SEWAGE DISPOSAL SYSTEM
MARYLAND STATE DEPARTMENT OF HEALTH

SUBDIVISION ROAD 12550 Hall Shop Road LOT Parcel 2

Re: Building Permit #39833
Proposed Addition
12550 Hall Shop Road

5/11/83
Sketch of
F.S.

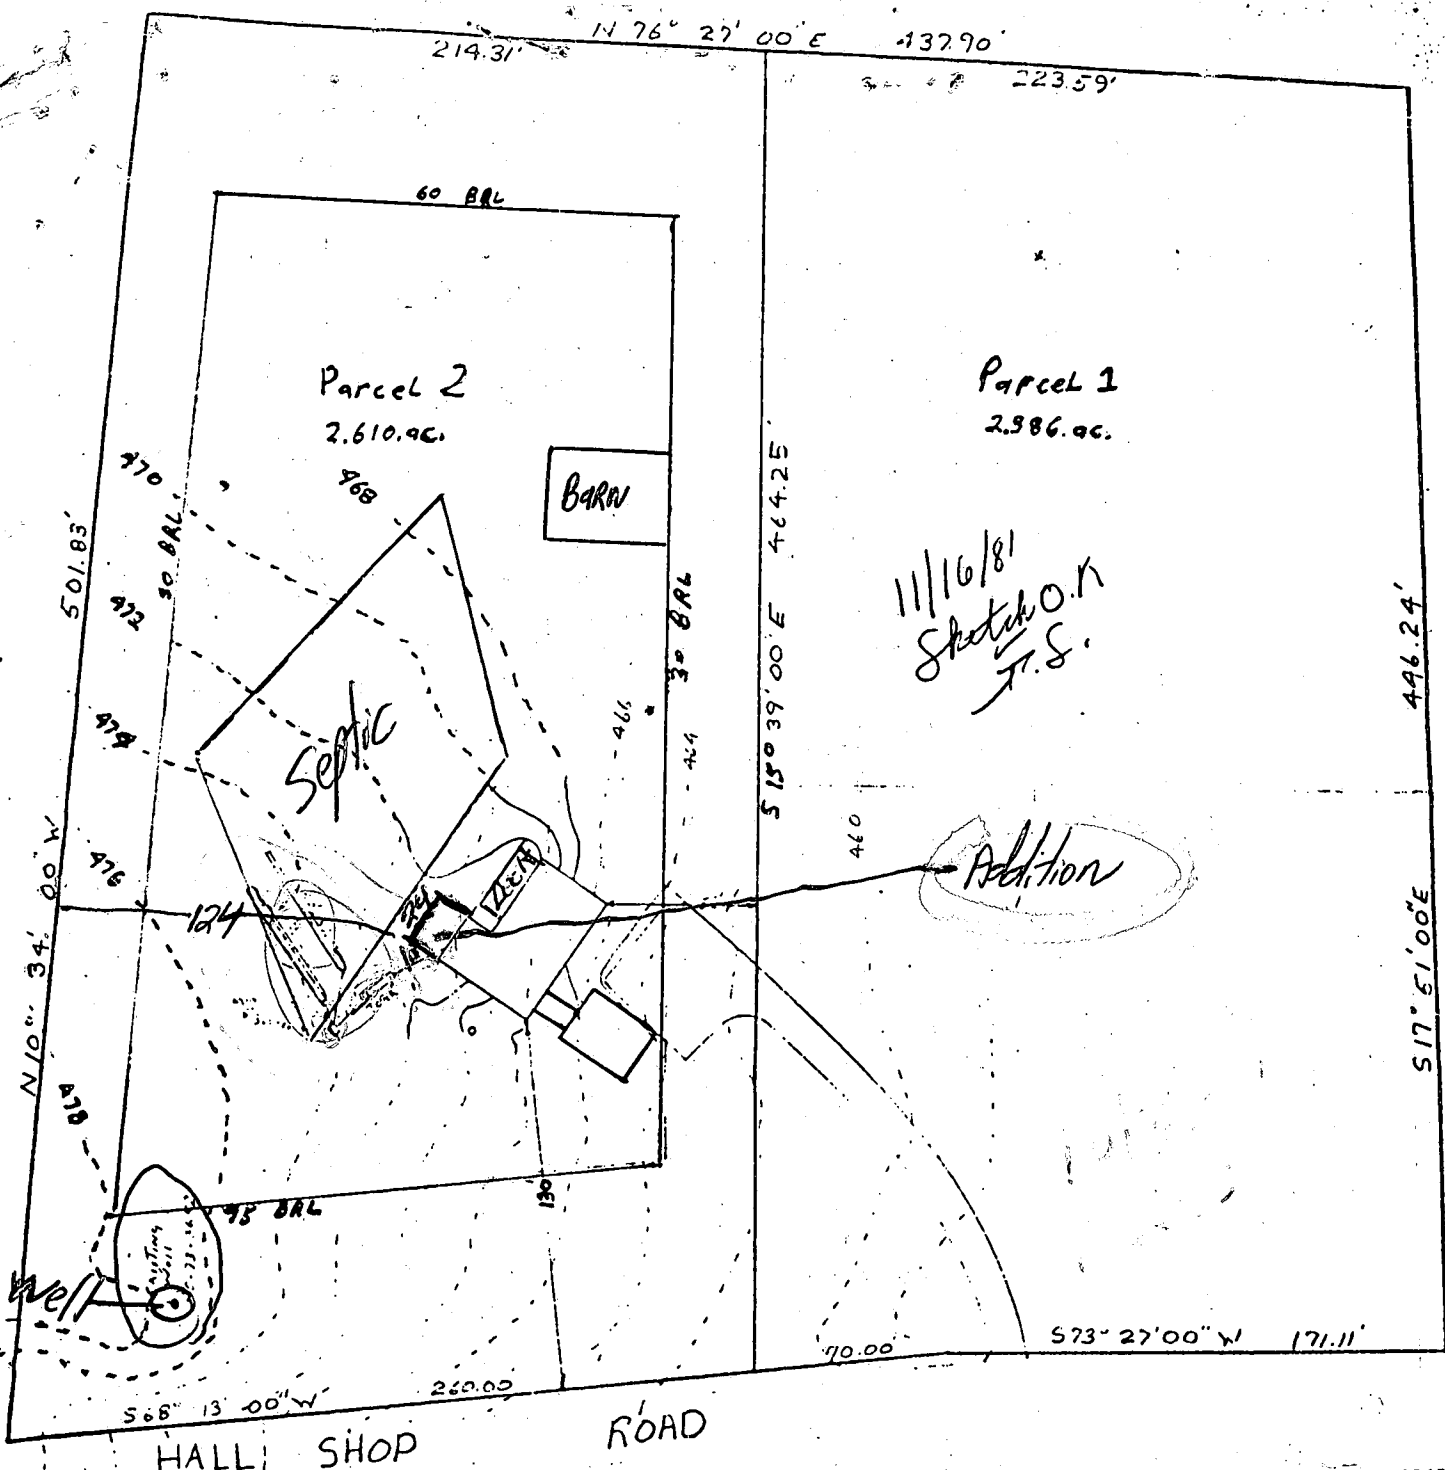
There is no Basement
and I can use either footings 30"
OR pier and post.

11/16/81
~~Sketch OK~~
J.S.

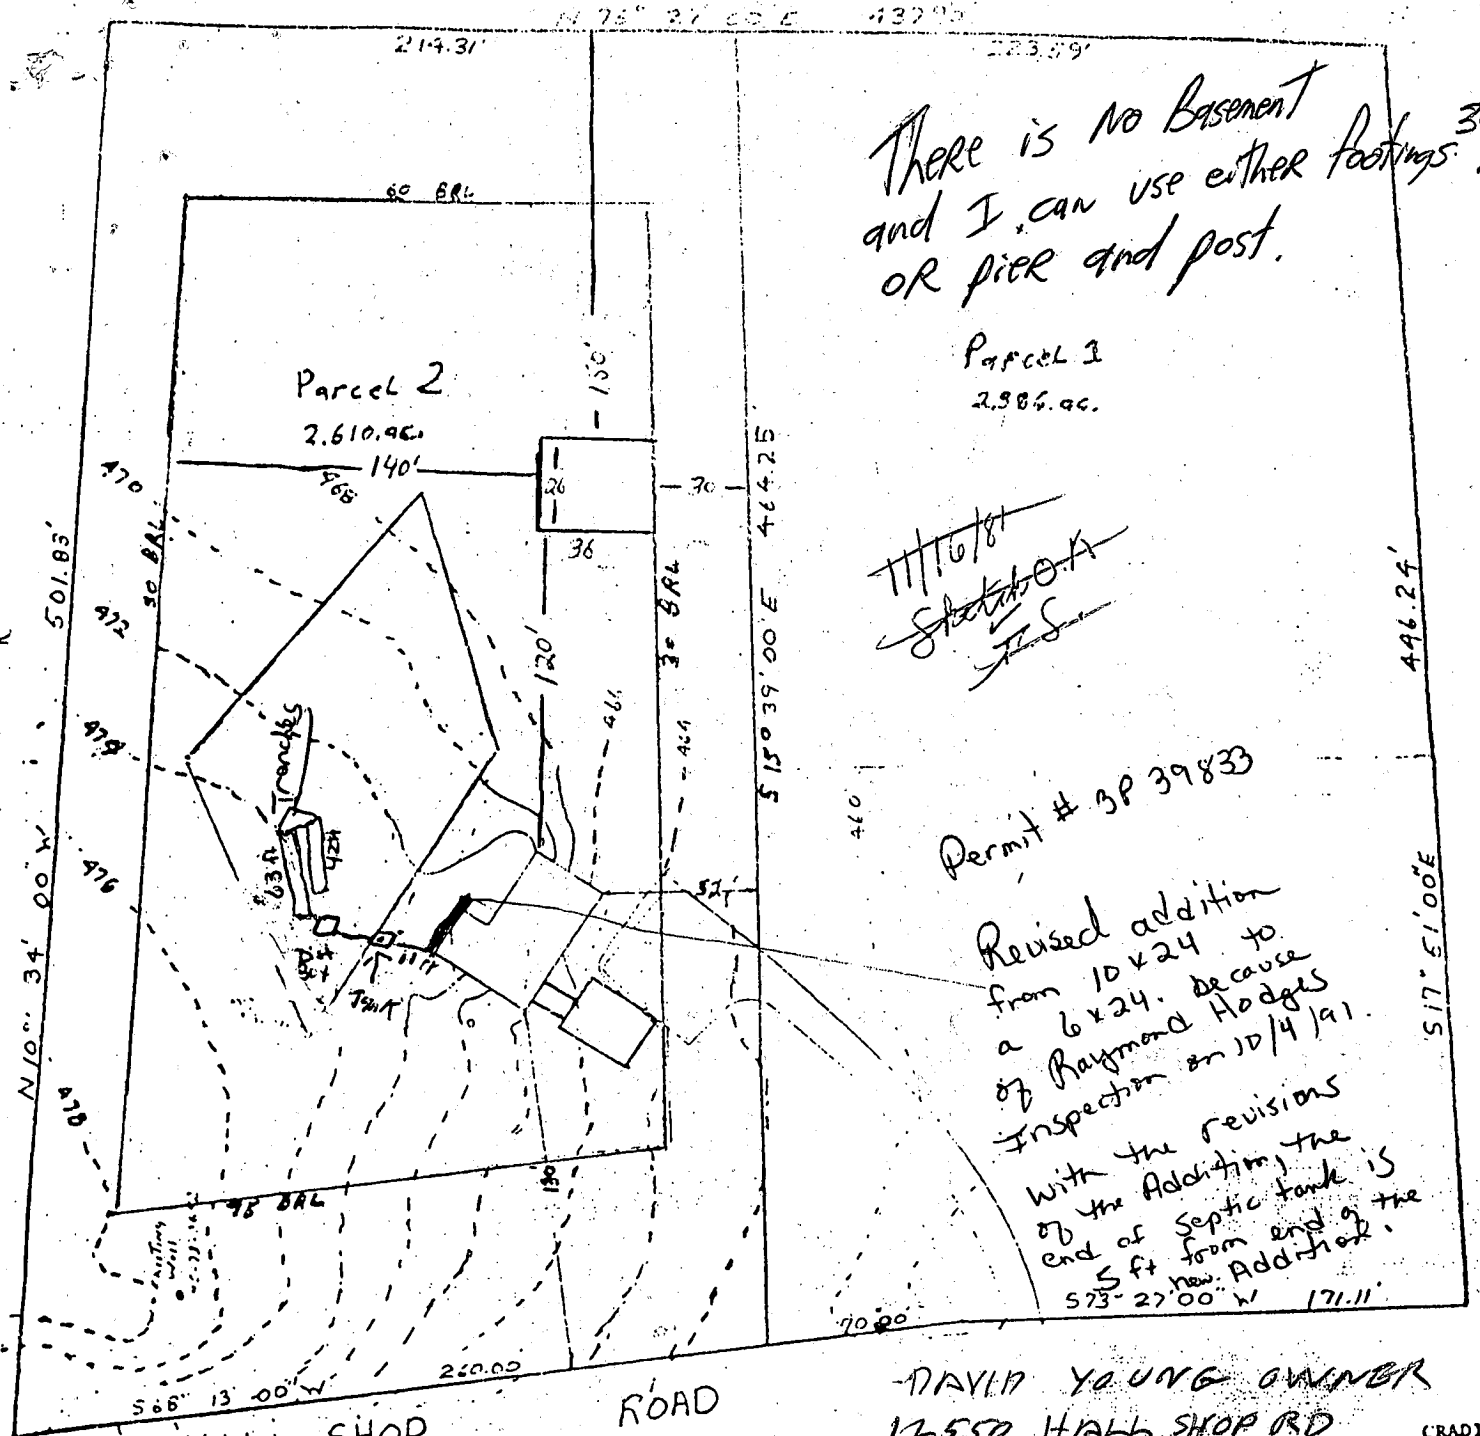
Revised addition
from 10x24 to
a 6x24. because
of Raymond Hodges
inspection on 10/4/91.
With the revisions
of the Addition, the
end of Septic tank is
5 ft from end of the
new Addition.

This is to advise that the above referenced building permit application cannot be recommended for approval at this time. The septic tank appears to be inaccurately located on the submitted site plan; its actual location may be in conflict with the proposed addition.

As discussed with you at the site, please submit a revised site plan showing the accurate position of the septic tank. If, as suspected, that location is less than 10 feet to the proposed addition, then relocation of the tank or the addition would be in order.

10/9/91
REVISED PLANS OK
R.H.

NEVER SENT
APPLICANT RESPONDED
WITH A REQUEST
TO MAINTAIN
5' CLEARANCE
TO TANK /
SLAB ON GRADE CONSTRUCTION
NO FOUNDATION.
PERMIT APPROVED
10/10/91
R/Hodges
